DESIGN RESPONSE

ADG SOLAR ACCESS

DA RESPONSE

SUMMARY - SOLAR ANALYSIS

STAGE 1 SUN EYE VIEWS 8AM - 11AM: *UNITS REQUIRING CLARITY*

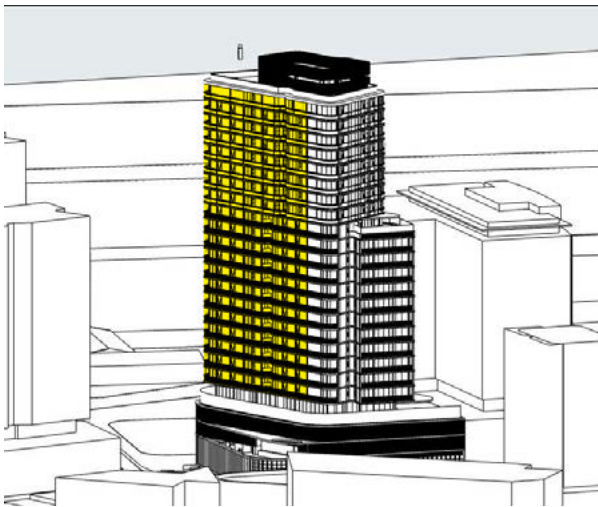
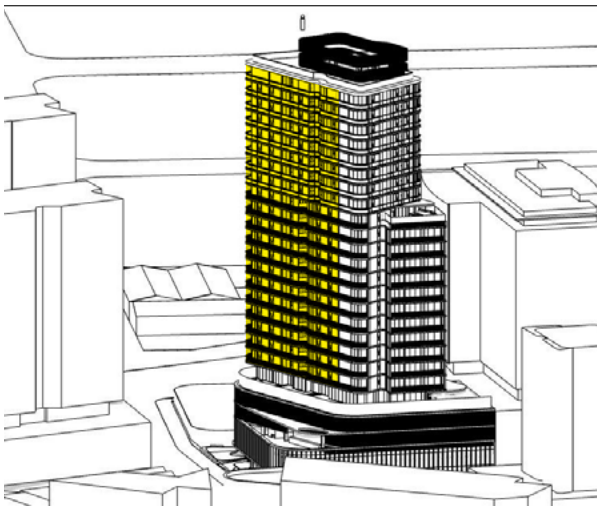
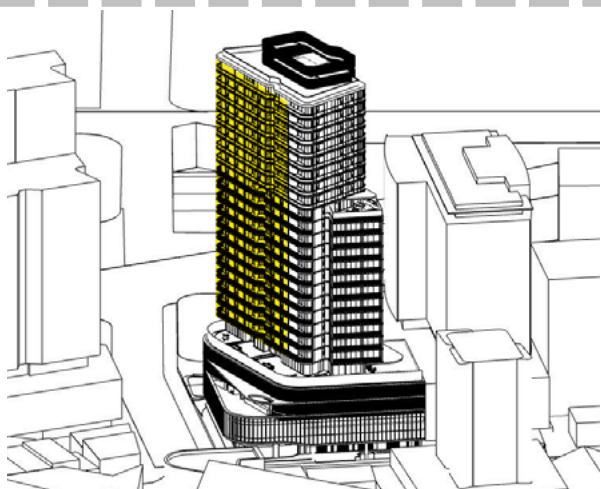
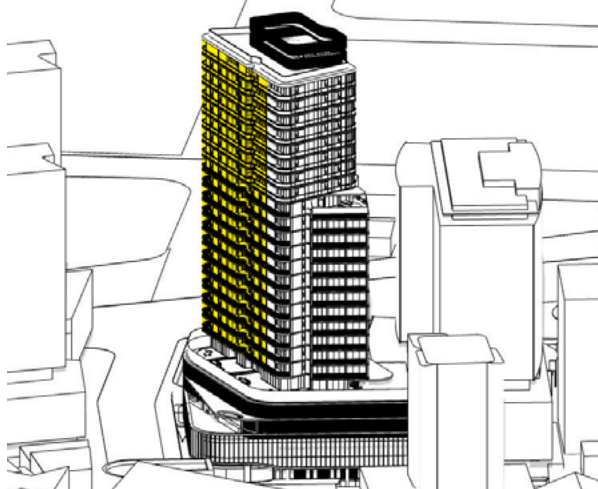
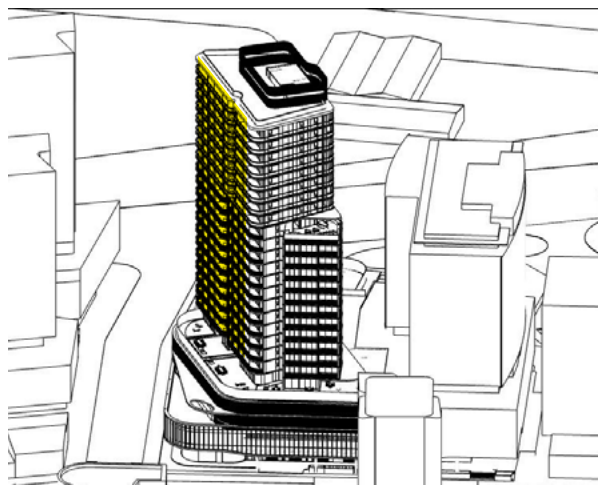
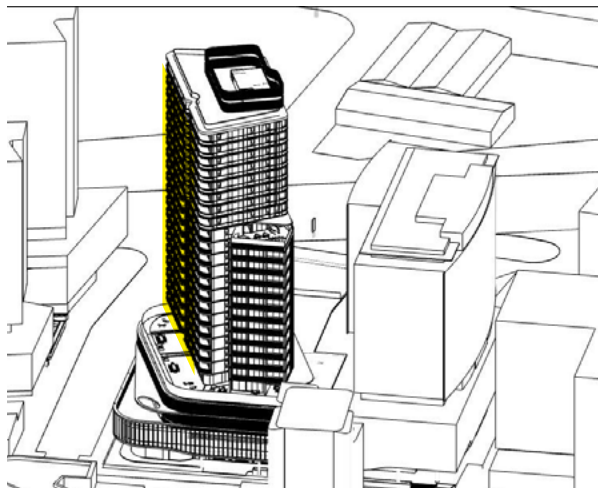
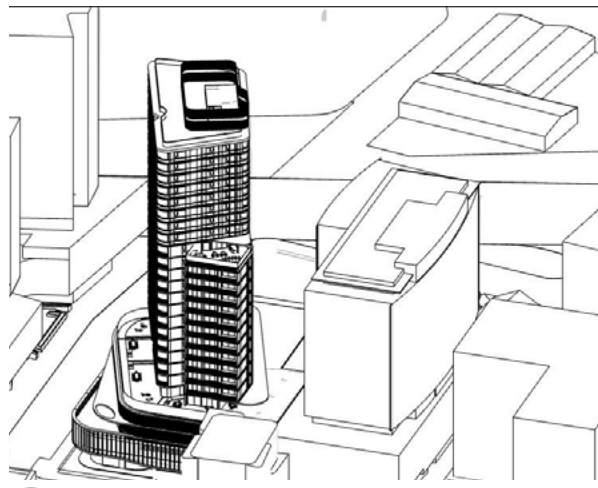
For Stage 1, additional clarity has been provided in response to Council's independent review for 58 units to demonstrate how they are achieving the required minimum 2hrs to their main internal living space and balconies in mid winter.

All of these are situated on the south east facade which are shown in the sun eye views to get the required sun between 9am and 11am, and can achieve more continuous hours from 8am.

STAGE 2 SUN EYE VIEWS 8AM - 10AM: *UNITS REQUIRING CLARITY*

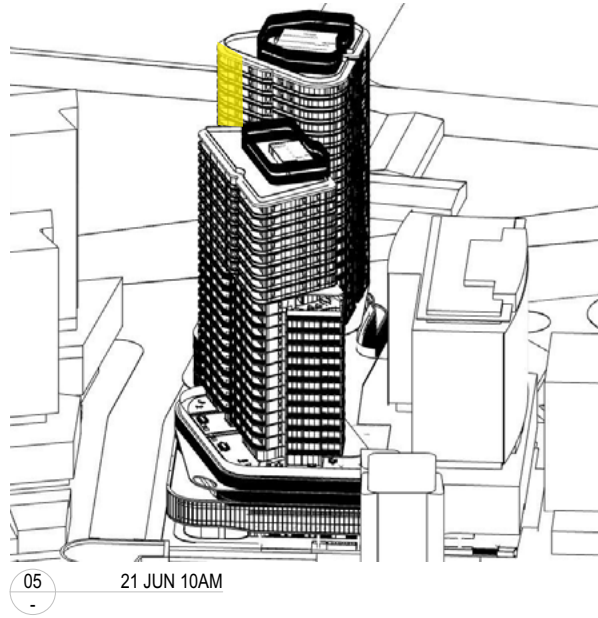
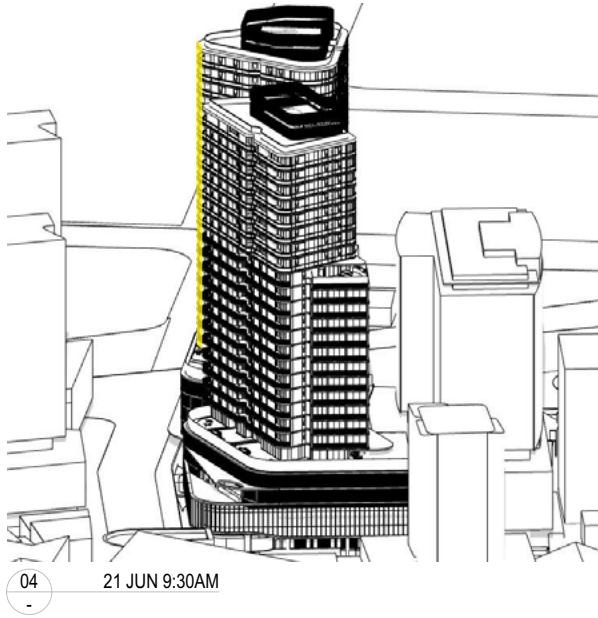
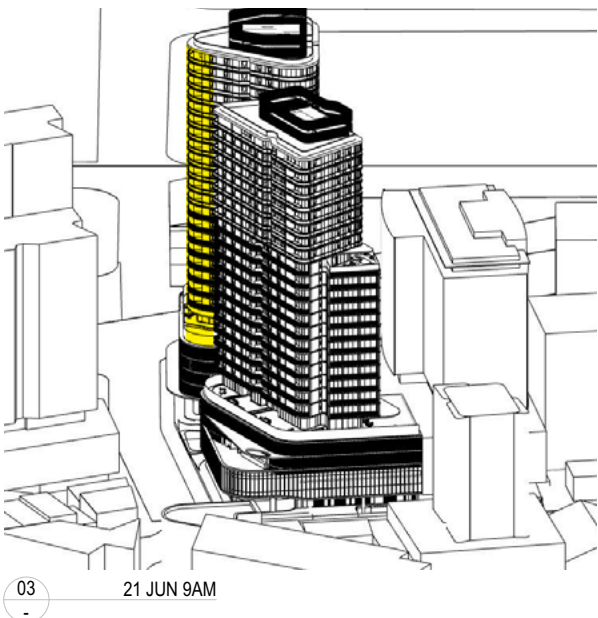
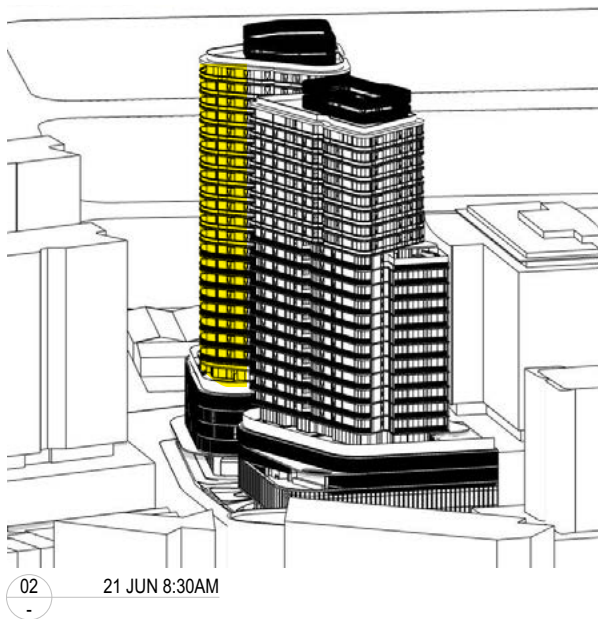
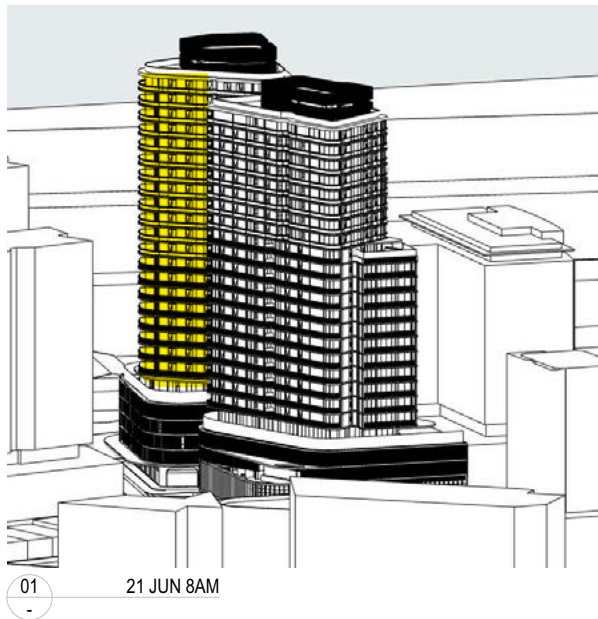
For Stage 2, additional clarity has been provided in response to Council's independent review for 17 units to demonstrate how they are achieving the required minimum 2hrs to their main internal living space and balconies in mid winter.

Most of these are situated on the north east facade which are indicated in the sun eye views to get direct sun around 9-9.30am, and between 11am and 12.30pm, and can achieve more continuous hours from 8am.

STAGE 2 SUN EYE VIEWS 10:30PM - 1:30PM: *UNITS REQUIRING CLARITY*

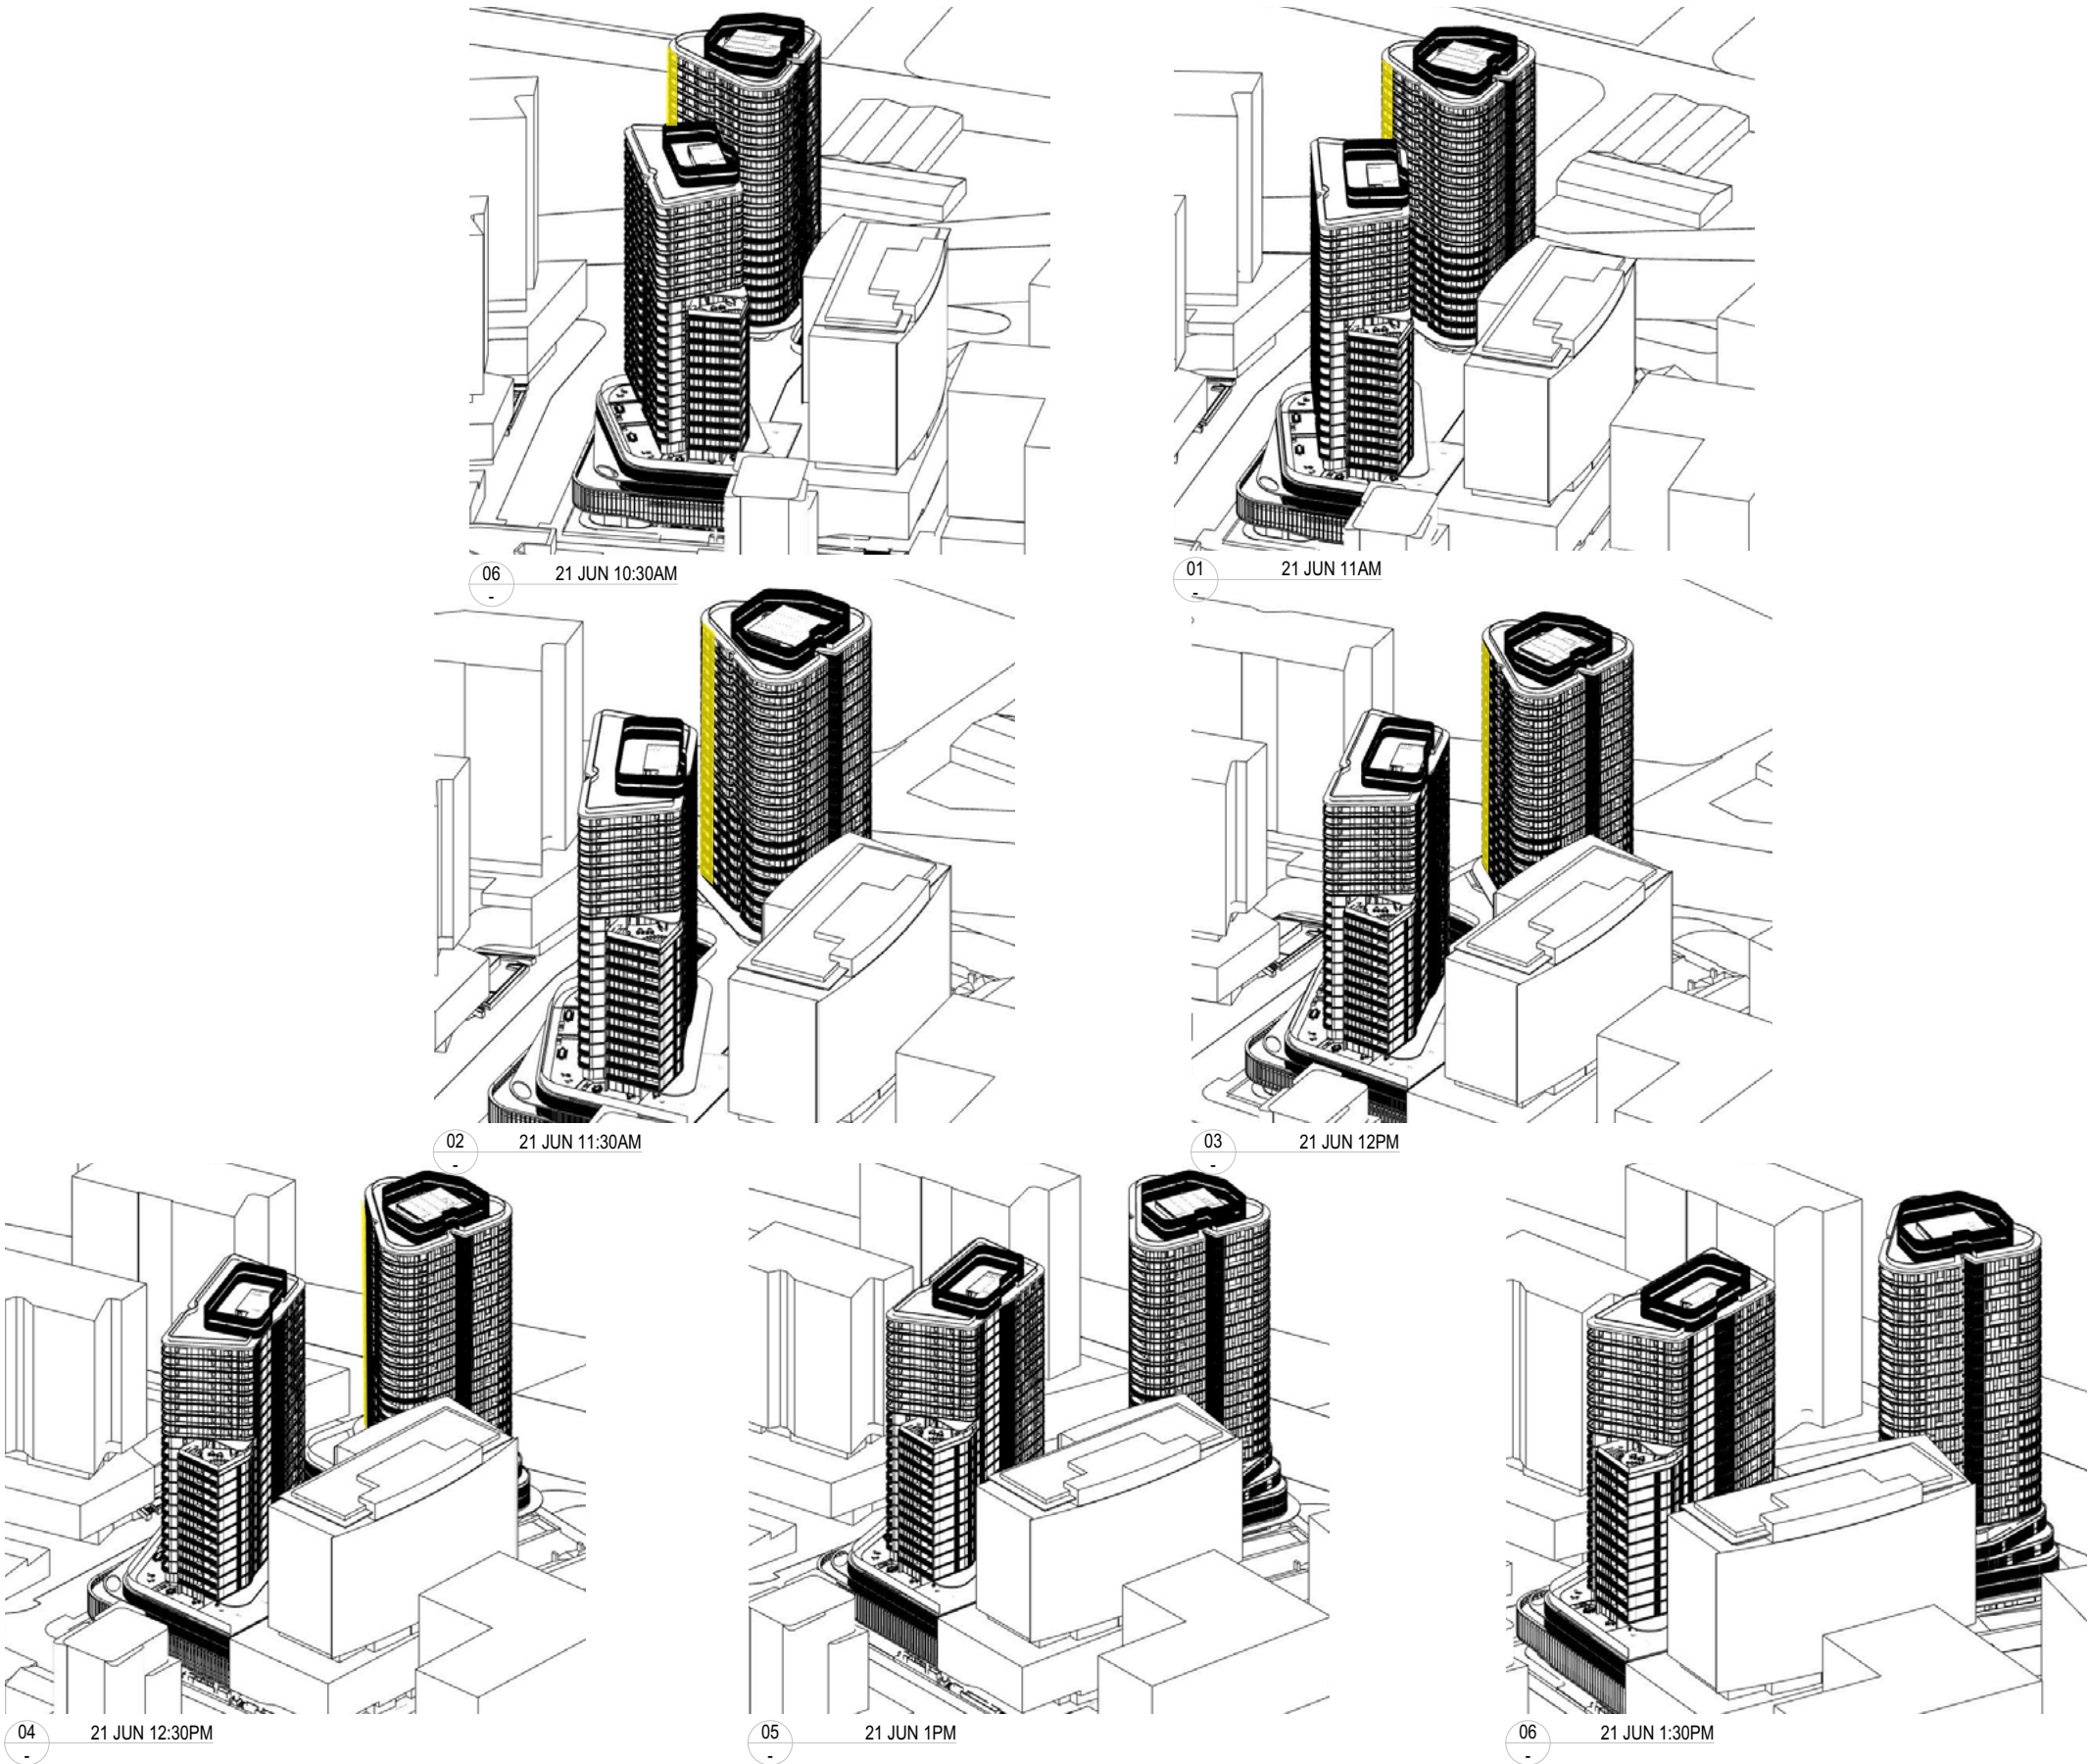
For Stage 2, additional clarity has been provided in response to Council's independent review for 17 units to demonstrate how they are achieving the required minimum 2hrs to their main internal living space and balconies in mid winter.

Most of these are situated on the north east facade which are indicated in the sun eye views to get direct sun around 9-9.30am, and between 11am and 12.30pm, and can achieve more continuous hours from 8am.
